**REVIEW OF THE
LAKE ONTARIO-ST. LAWRENCE RIVER
STUDIES**

Committee to Review the Lake Ontario-St. Lawrence River Studies

Water Science and Technology Board

FIGURE 2-4 Circular ratio plots of multiple performance indicators in the Board Room.
SOURCE: Board Room, Toronto Board Room April 24.xls (SVM 2).

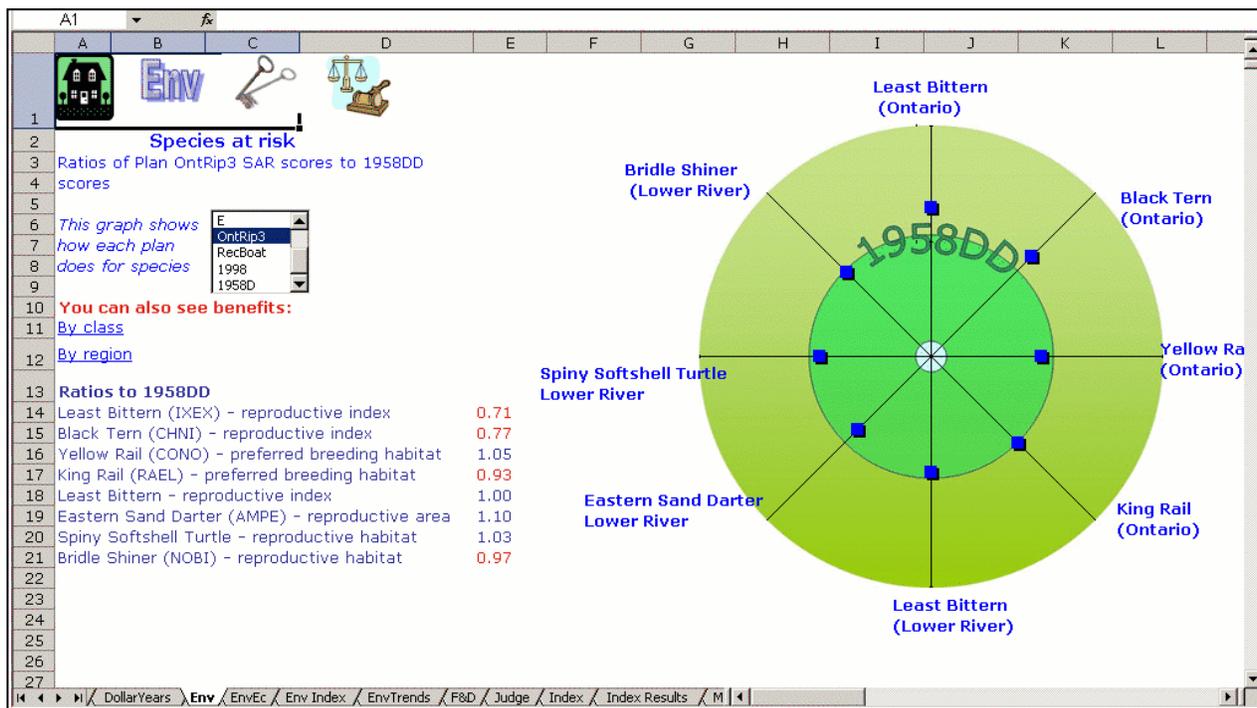
Many of these displays are creative and useful. Some, like the circular ratio plots, allow comparison of a wide suite of performance indicators (Figure 2-5), while others present data aggregation problems that will be elaborated in chapter 4.

FIGURE 3-3 Cosmos modeling of cumulative recession (FEPS 7, p. 11).

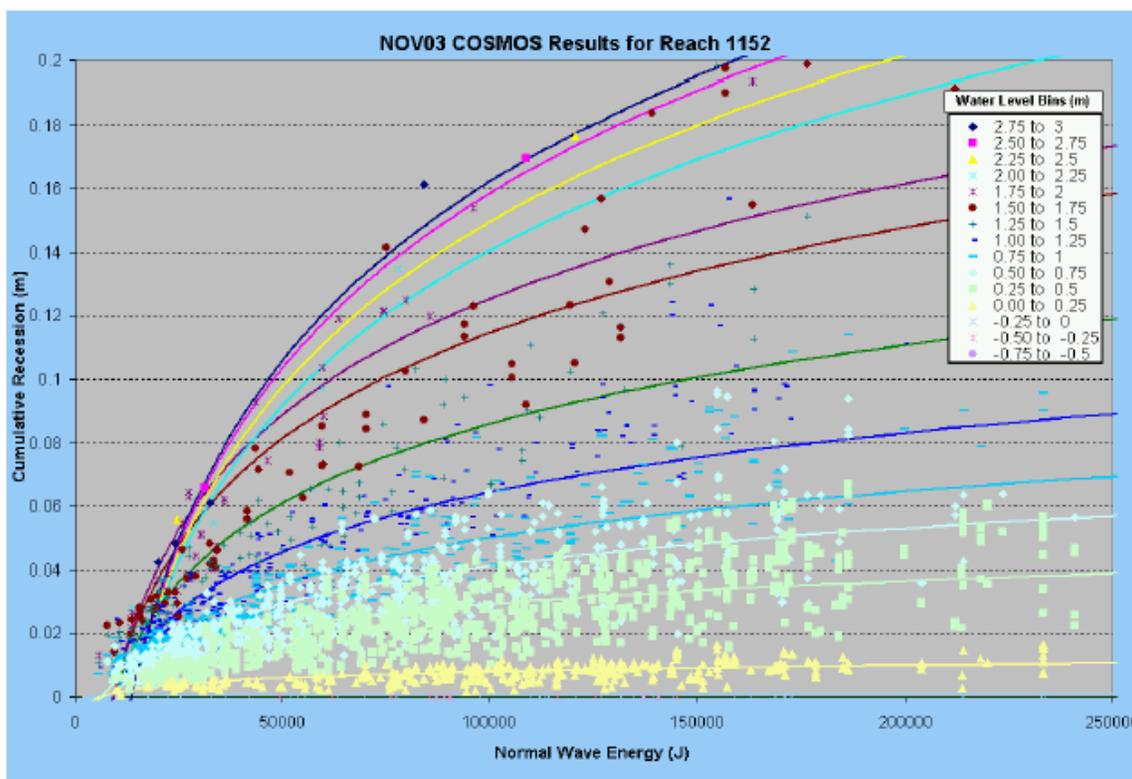
- e) The data used for fitting the regression for recession displays high variability (fig. 3.6) (FEPS 7). Figure 3.6 indicates very high variability of data used for the regression. The quality of the fit and the error do not appear to have been assessed (at least it has not been documented)

The uncertainty in the logarithmic regression equation is the most problematic aspect of the FEPS study because of its capacity to introduce and propagate error. All downstream modeling considerations are dependent, in part, on the logarithmic regression output. This dependence places critical importance on those output values being accurate; otherwise error will be propagated through the downstream models. Another problem stems from the use of the synthetic data set of monthly normal wave energy calculated by WAVAD and monthly recession calculated by COSMOS. The fit for the recession regression equation uses these data. Using synthetic data introduces unnecessary error (E1) on recession outputs, which subsequently are used as inputs for the regression analysis. Regression analysis produces its own error (E2) resulting in the aggregate error of E1+E2. The first type of error (E1) could presumably have been avoided by skipping the COSMOS process and using the observed recession data instead.

The uncertainty in the data used to derive the logarithmic relationship exhibits a great deal of scatter (Figure 3.6 of FEPS 7, p. 11, reproduced below, Figure 3-3). The horizontal axis extends to 250,000 J/m² and covers the range of the average yearly normal wave energy. However, the

WAVAD model predicts January wave energy in excess of $600,000 \text{ J/m}^2$. The rate of change of the predicted recession decreases rapidly as wave energy increases. This implies that recession during severe winter storms will be similar to that for significantly lesser storms. From the materials presented for review, it was not possible to determine whether this feature of the model is reasonable. Thus calibrating the recession regression equations to within less than 10% of the COSMOS model equations has little effect because the scatter around the COSMOS regression equations is greater than 10 percent. The uncertainty in parameters “a” and “b” must be significant, such that it may not be possible to make a reasonable distinction between the recession rates associated with different plans. As noted above, the problem of calibrating the model for conditions beyond the bounds of the empirical data introduces additional uncertainty that renders the forecasts questionable. **The lack of specific treatment of uncertainties in the coastal recession regression model, especially parameters “a” and “b,” make objective discrimination between the coastal impacts of regulation plan options impossible.**

FIGURE 3-4 Spatial and temporal scales.

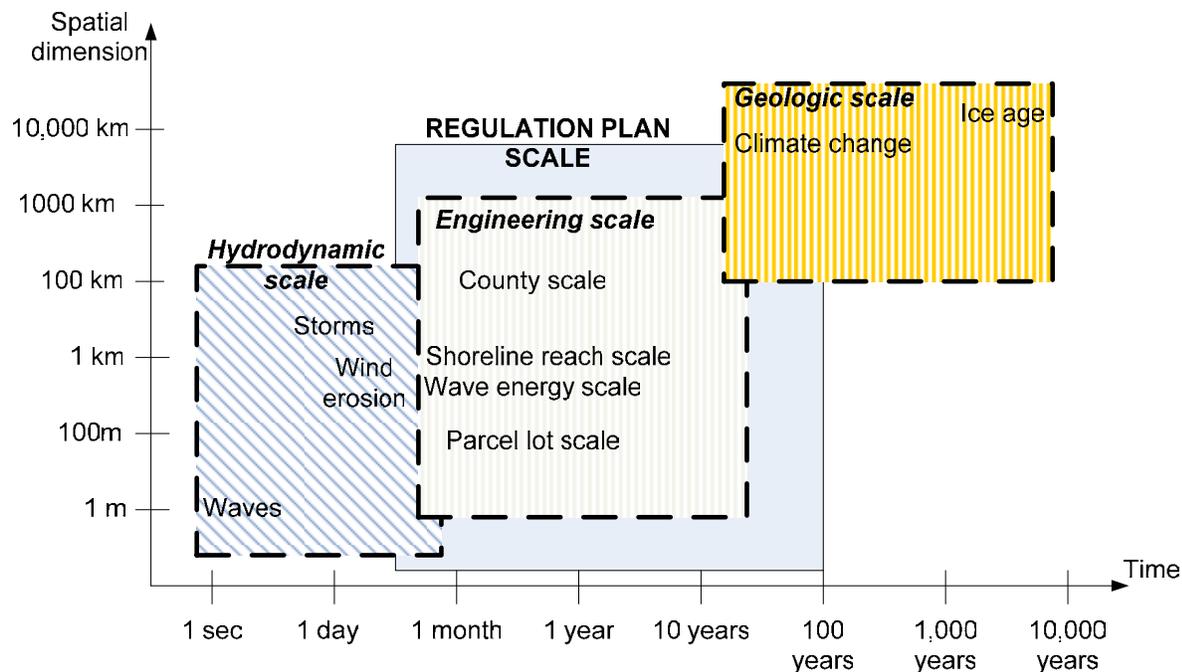
The FEPS modeling endeavor requires specific scales to be adopted for each of the sub-modeling efforts, making it necessary to scale the results of the analysis in both space and time. In Figure 3-4, “Time” reflects the temporal extent over which the erosion/damage parameter and planning horizon occur. “Spatial dimension” reflects the geographical extent and lake level fluctuation of those erosion/damage parameters and planning horizons. The FEPS process would be expected to illustrate where in this space-time context data are collected, processes modeled, and inferences made. The spatial and temporal resolution of elements in the FEPS model and sub models are illustrated conceptually in Figure 3.4. Describing the FEPS work in such a context would provide a basis for framing consultations, discussions, and debate around issues of modeling resolution and the sphere of applicability of FEPS results.

The model documentation appropriately addresses issues of resolution. In its discussion, it identifies some limitations to the FEPS model. It specifically notes the lack of parcel-level detail that precludes more than an order of magnitude forecast at the reach scale (FEPS 8, p. 20), which means that FEPS cannot capture dramatic changes in local shoreline conditions that can occur during individual storms. The FEPS model, however, would be most useful under such conditions when it could convey predicted responses to interested parties, such as riparian and shoreline owners, the IJC, or others in the political process.

FIGURE 3-5 Spatial scale, analytical rigor, and accuracy and precision of results.

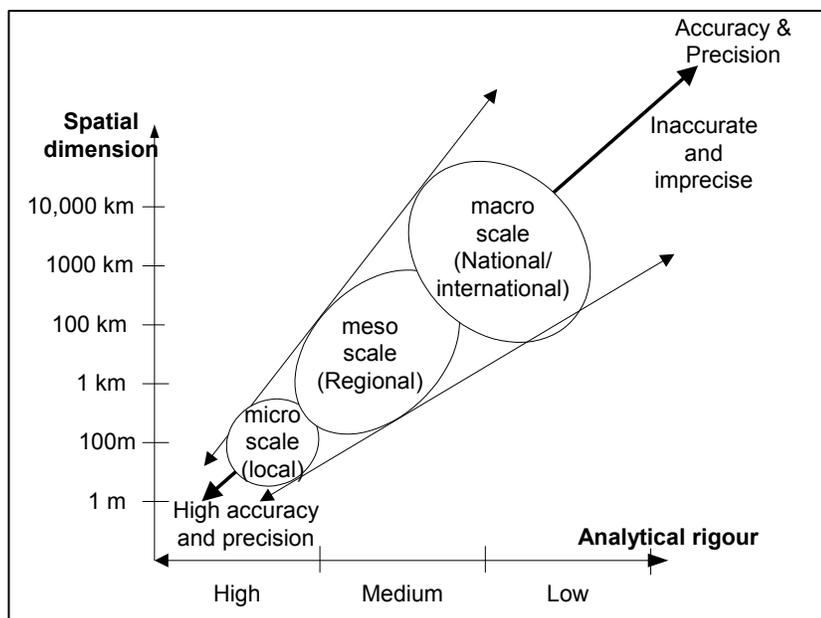
Relationships among spatial dimension, analytical effort, and the accuracy and precision of results are represented schematically in Figure 3-5. From the information available, it appears that the FEPS modeling endeavor is at the meso-scale spatially (FEPS 7, p. 3). The mathematical scaling in space and time of the “Families of Equations for Regional Zones” (FE_q), the “Local Wave Energy (We_l),” and the Annual Average Recession Rate (AAAR) measured over each 1 km reach is not specified. The FEPS modeling endeavor is considered to be of low- to medium- analytical rigor, due in part to the regression equations and in part because there are at least two higher levels of analysis available. The highest level of rigor is structural reliability modeling on a parcel lot-by-parcel lot basis using detailed wave and hydraulic models. The next highest level of rigor is multiple COSMOS-type modeling on a 1-km reach basis over the entire lake and river.

The treatment of spatial and temporal scaling requires considerable additional effort to enable a comprehensive evaluation and understanding of flooding and erosion hazards associated with regulation plan options.

FIGURE 4-1 Distribution of wetlands by geomorphic types in Lake Ontario and the St. Lawrence, with respect to a) total area and b) total number.

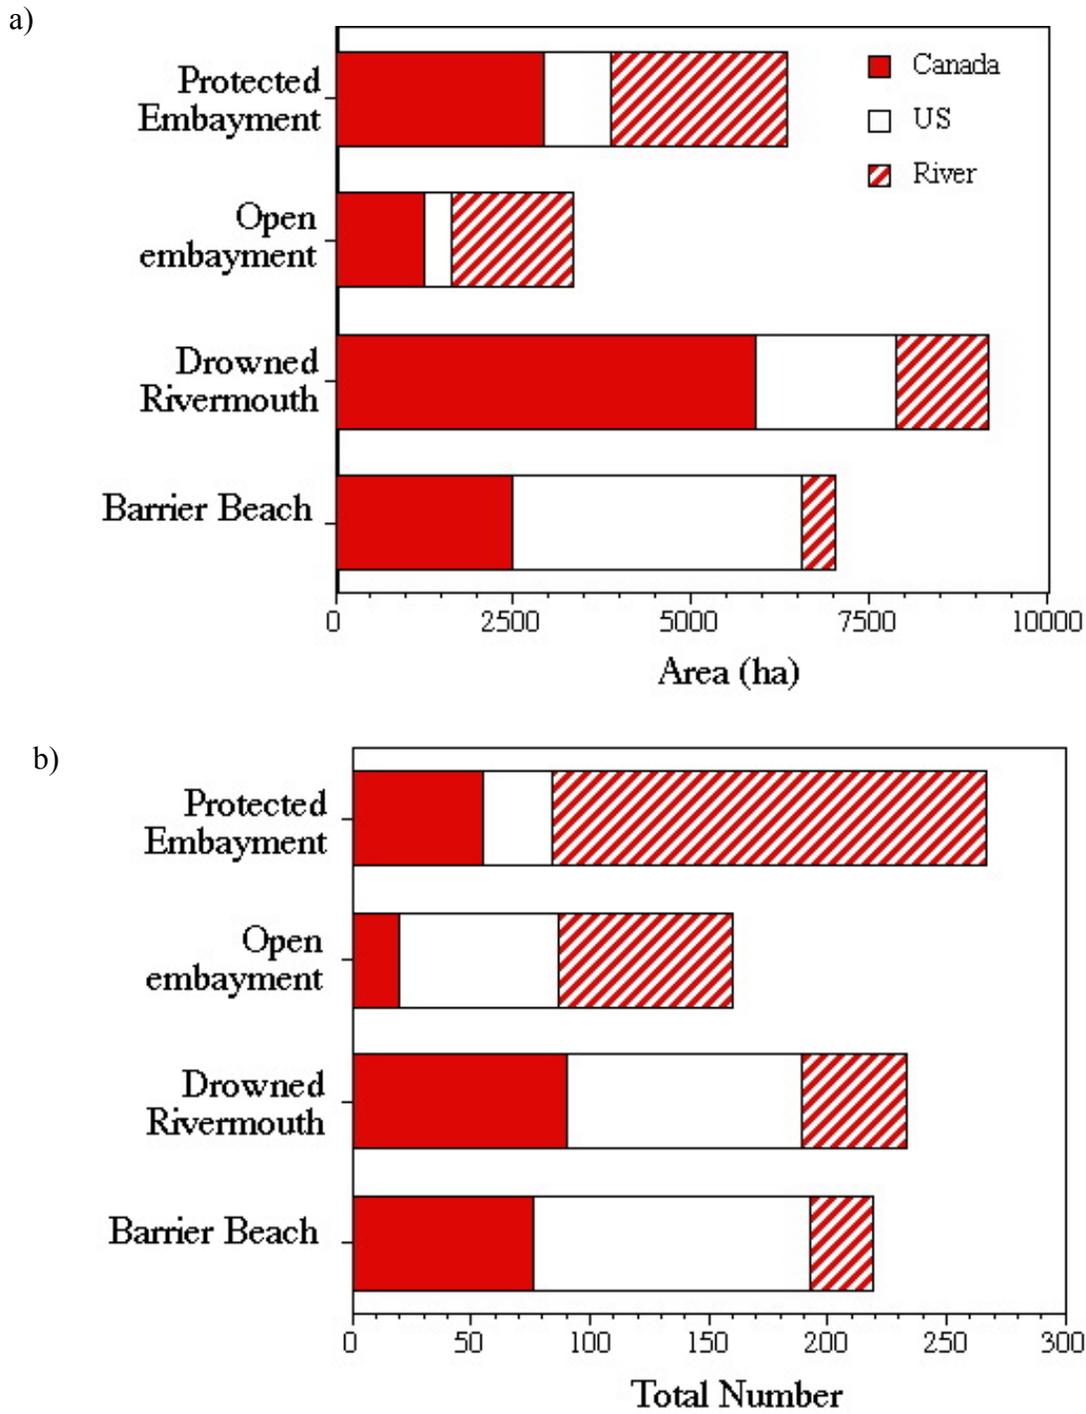
Figure 4-1 and Table 4-1 illustrate the representativeness of the suite of study sites. For example, there are very few open embayments in Lake Ontario, and most of these occur in the U.S. and along the river (Figure 4-1). The average size of wetlands in the U.S. ranges from 6 ha for open embayments to 35 ha for barrier-beach wetlands. By comparison, the average size of Canadian wetlands is much larger, 33 ha for barrier-beach to 66 ha for drowned river mouth marshes. The average size of riverine wetlands tends to be intermediate, from 21 to 39 ha (Table 4-1). Compared with what is available, the average size of wetlands sampled in this project was between 19 and 46 ha, generally much larger than the average wetland in the United States, except for the barrier-beach type (Table 4-1). Unfortunately, the degree to which these untested assumptions of representativeness contributed to error propagation is unknown. **A thorough analysis of the wetland study should document how well the sampled sites represent wetlands across Lake Ontario and the St. Lawrence River**
